REVISION:
B

SHEET No:
1 OF 5

Riverdell Fairway

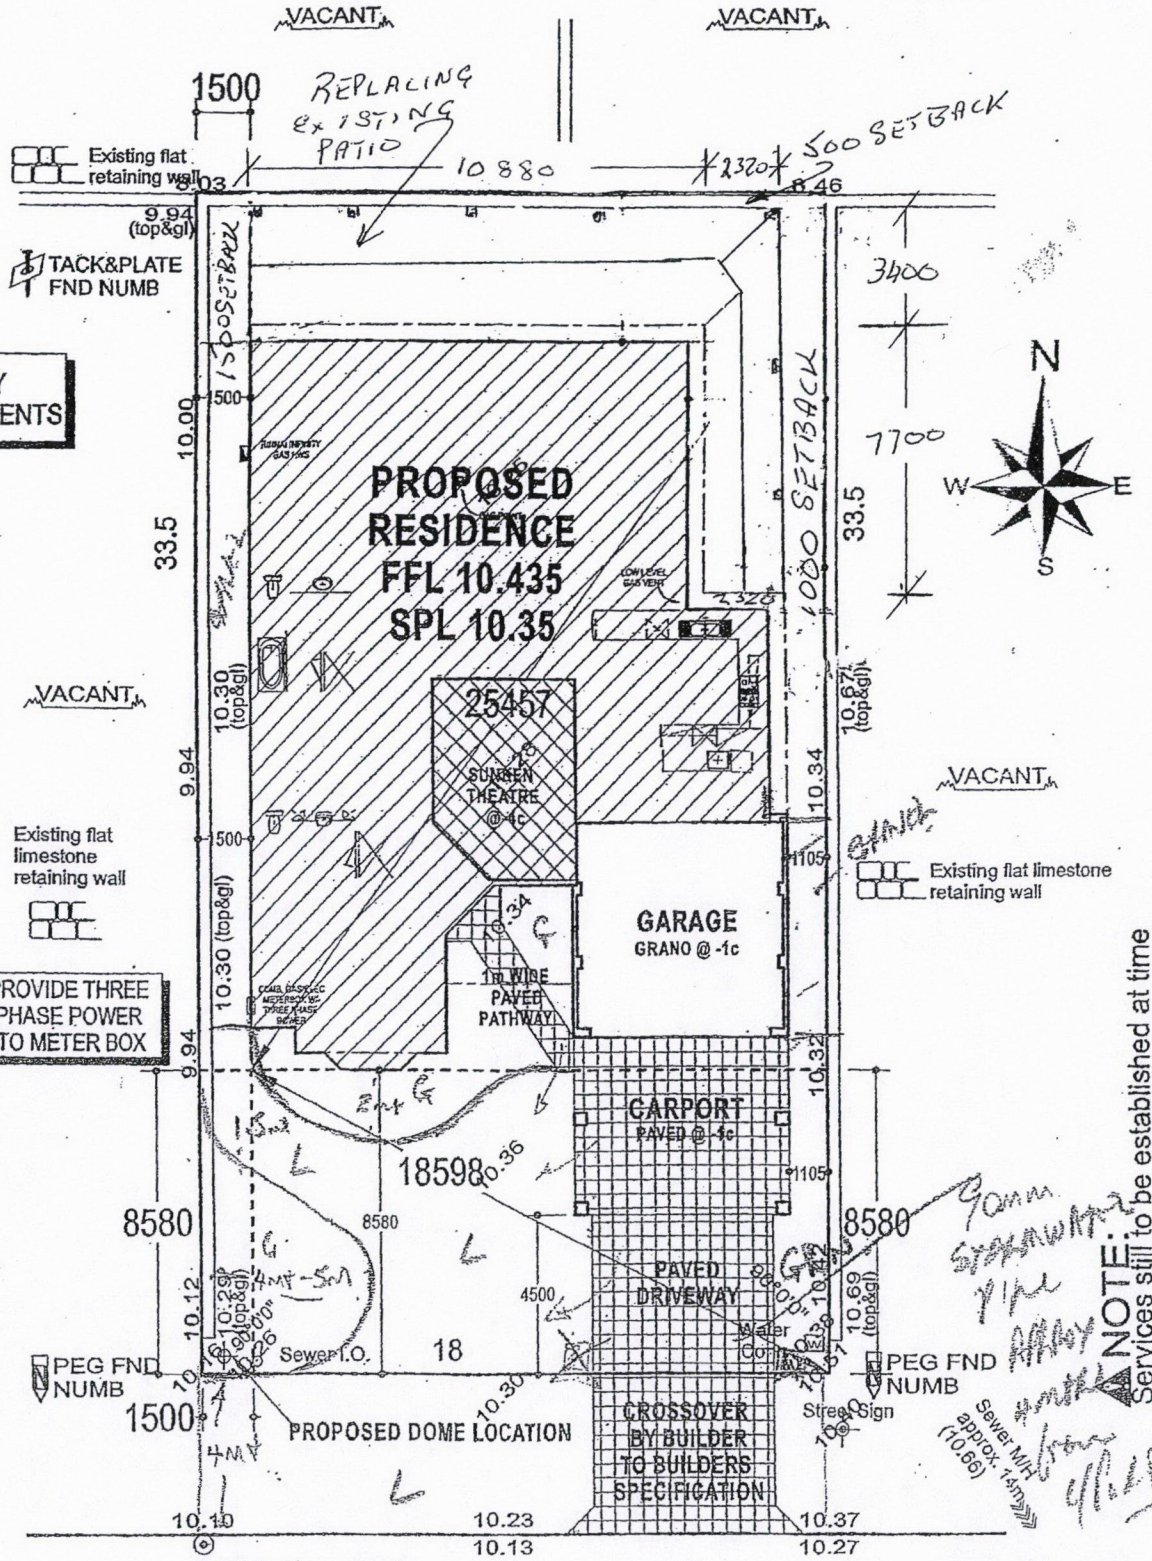
Handwritten notes:
Gonna separate the driveway with the fence
Sewer M/R approx. 1.4m @ (10.69)
